TITLE: WAFER 2.54mm PITCH		<b>HOMETOM</b> www.hometom.com.tw <b>HORNG TONG ENTERPRISE CO.,LTD.</b>	
TOLERANCE	APPROVAL:	UNIT: mm	PART NO: WF**R2****113
LINEAR: X ±0.30 X ±0.25 XX ±0.20	ANGLE: X° ±2° X° ±1° XX° ±0.5°	CHECK:	SIZE: A4
CUSTOMER DRAWING	REV: M	DRAWN:	SCALE: 4:1
		PRJ.:	SHEET: 1 / 2

深圳市紘通电子有限公司 變更通知(ECN)

ECN Form with fields for Product Name (WAFER 2.54mm PITCH), Material No. (WF\*\*R2\*\*\*\*113), Version (L to M), Change Purpose (Correct electrical specifications), and various approval checkboxes.

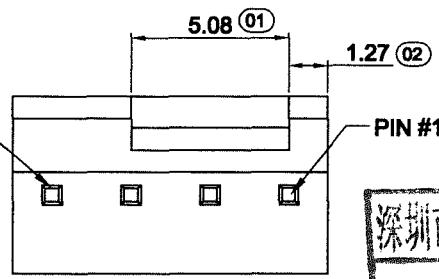
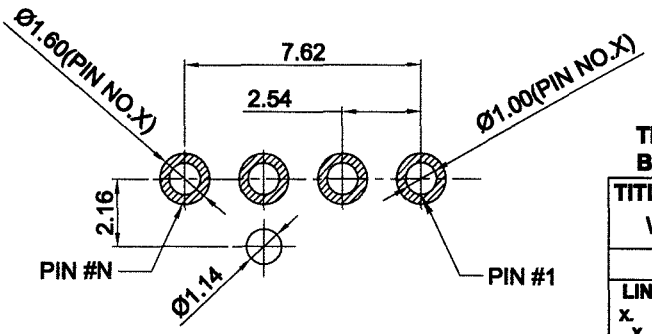
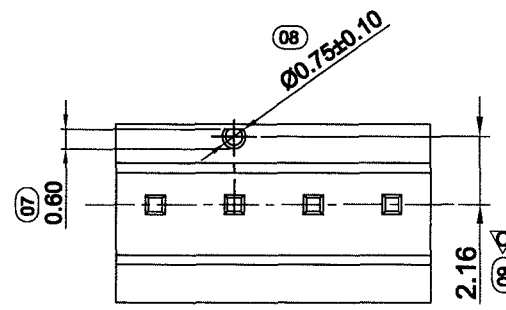
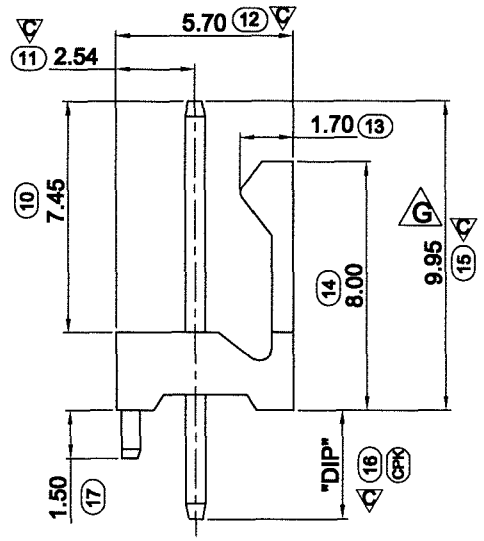
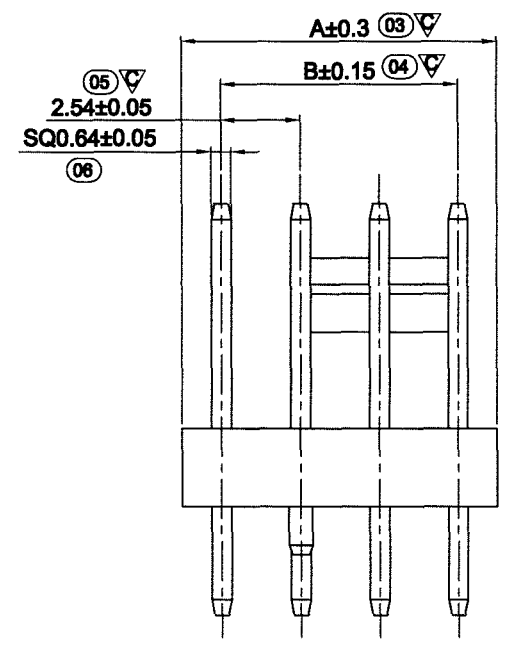
REV.	ECN NO.	DESCRIPTION	DWN.	APVD.	DATE
L	BN17121501	新增DIP3.80mm规格	XSY	DLQ	2017.12.15
M	BN24062701	Change color options	WF	CJM	2024.03.18
